Swift Cottage Bedroom, Half Bath & Closet Addition. Connective passageway from existing structure has been relocated to the kitchen of the existing structure. Window locations are still TBD. Windows will be casement, sized for egress. Addition has been relocated 3' to the north to avoid intrusion into the south side property setback (of 20'). Addition has been resized to reduce intrusion into the yard.

W. Swift – Revision 1, 5/25/17

Revision 2, 7/8/17, WLS

SCALE: 1/4" = 1'-0"  
1ST FLOOR PLAN

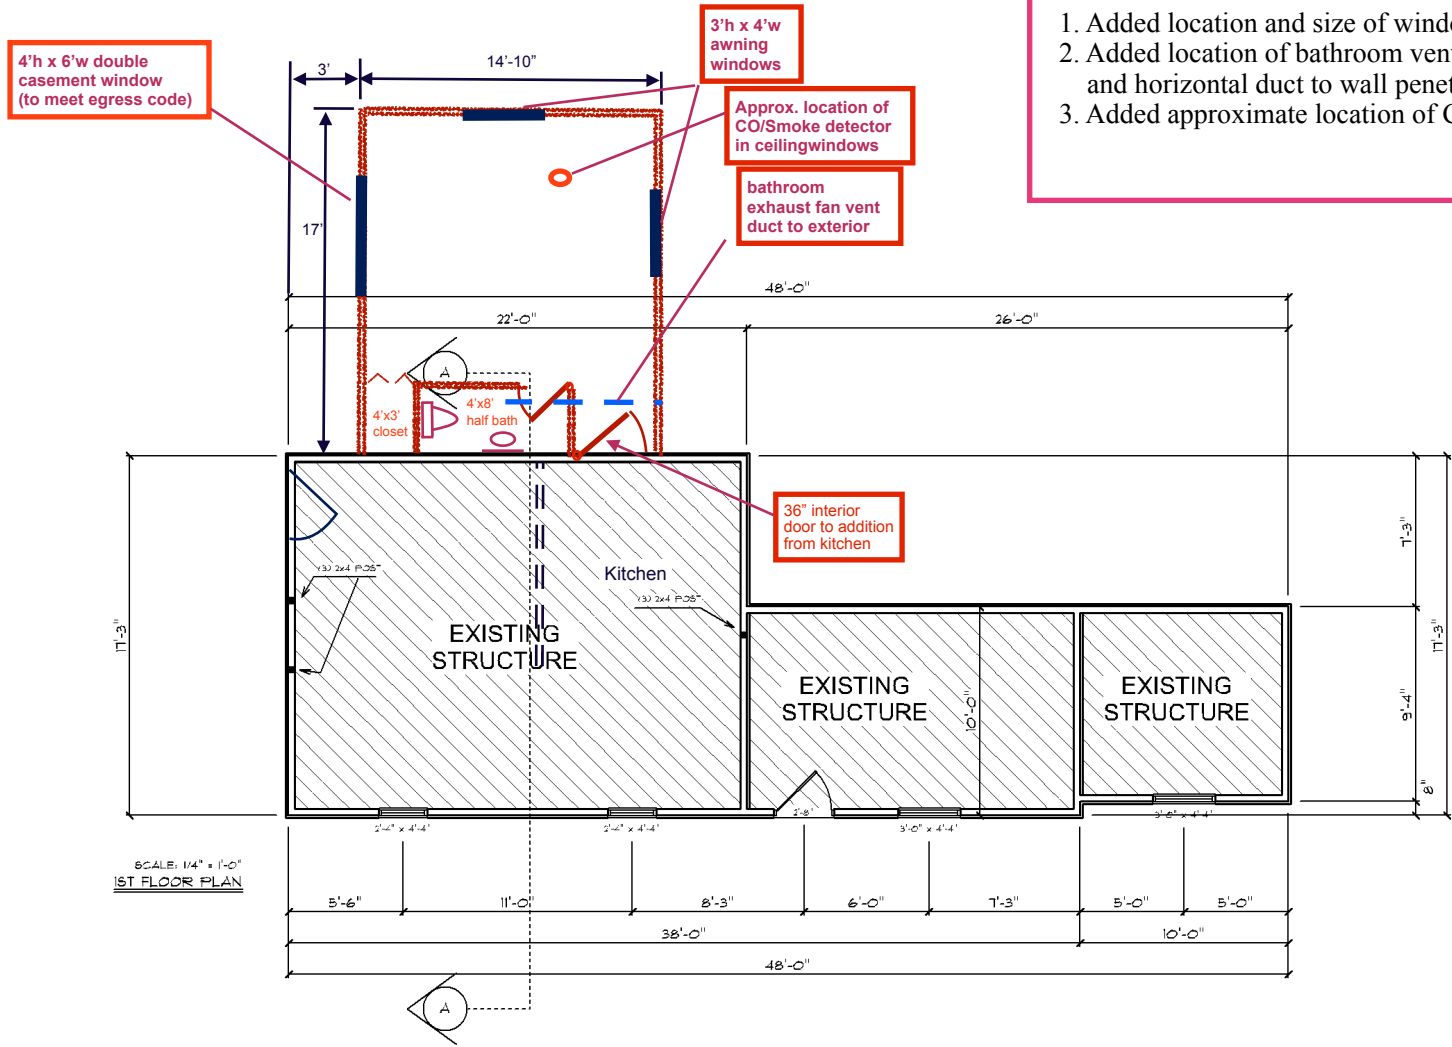
1. Added location and size of windows.
2. Added location of bathroom ventilation up through ceiling and horizontal duct to wall penetration.
3. Added approximate location of CO/smoke detector.
